TECHNICAL ANALYSIS

Genwal Coal Company, Inc.
Crandall Canyon Mine
New Lease
ACT/015/032
Emery County, Utah

March 20, 1991

STRUCTURE CONTOUR MAP
OF TOP OF HIAWATHA
COAL SEAM.

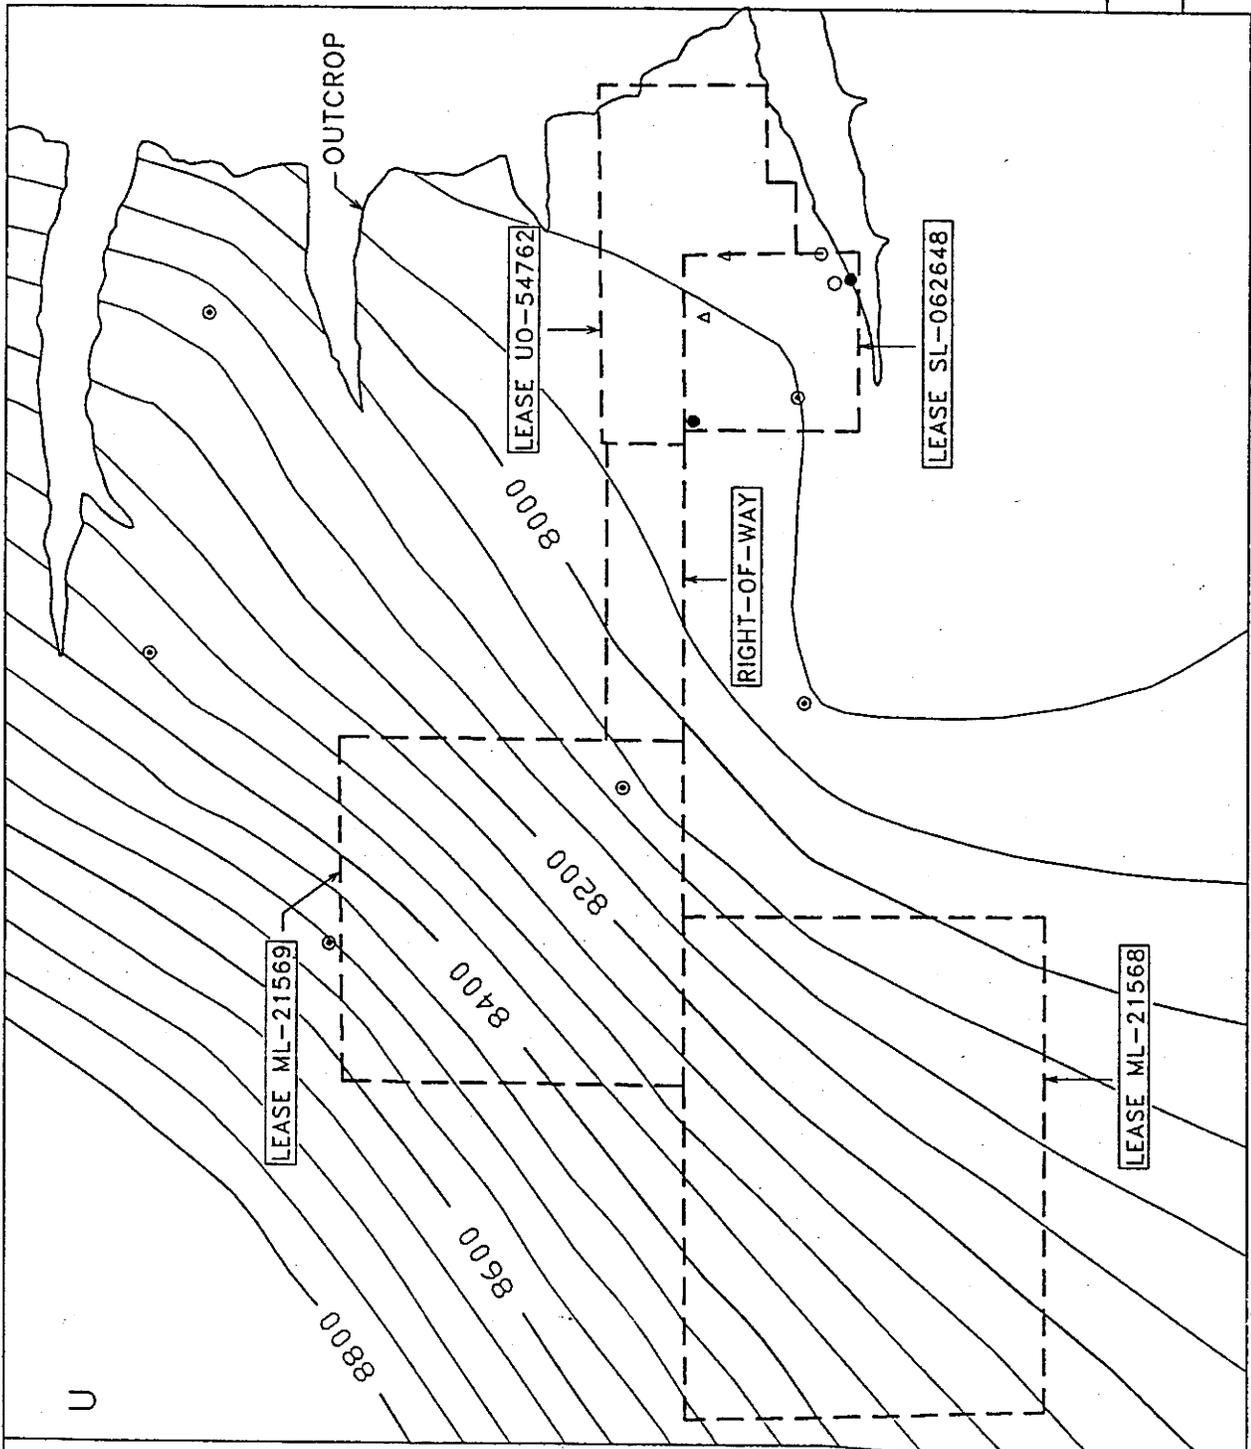
The Hiawatha Coal Seam is the only coal seam to be mined in the new lease area. It occurs at the base of the Blackhawk Formation. Maximum overburden is approximately 2100 feet in the middle of Section 36, and the minimum overburden lies in the stream channels of Blind Canyon and Crandall Canyon where the thickness is 600 feet and 900 feet (Figure 3). The entire permit area is underlain by the Starpoint Sandstone.
